Access Compliance Report

Public Rights-of-Way

(Curb Ramps)

Intersection ID: 2601	Main Street: PROSPERITY_CHURCH_RD	Cross Street: EASTFIELD_RD	Location:	N
ADA ID: 960F5C449061	Ramp Type: Perp	Initial Pass/Fail: Pass	Overall Compliance: No	Severity Score: 5.25
Codes/Mitigation Info/Possible Solution		Field Measurements/Component Compliance

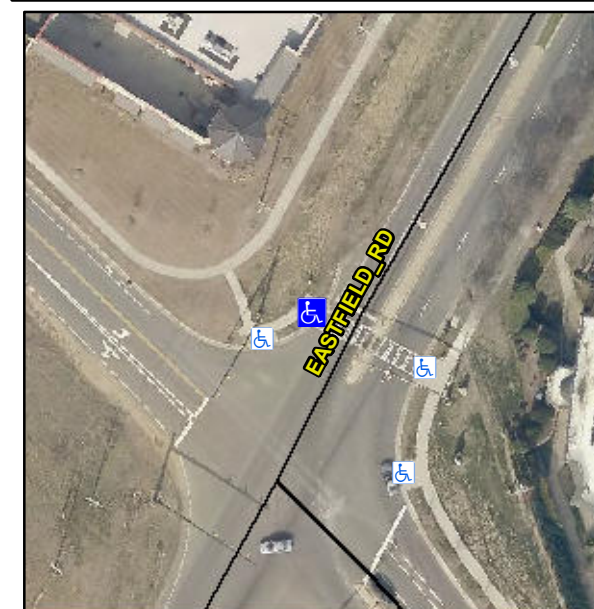
**Remove & Replace Entire Ramp.
Remove & Replace Gutter.**

R304.5.3, R304.5.4
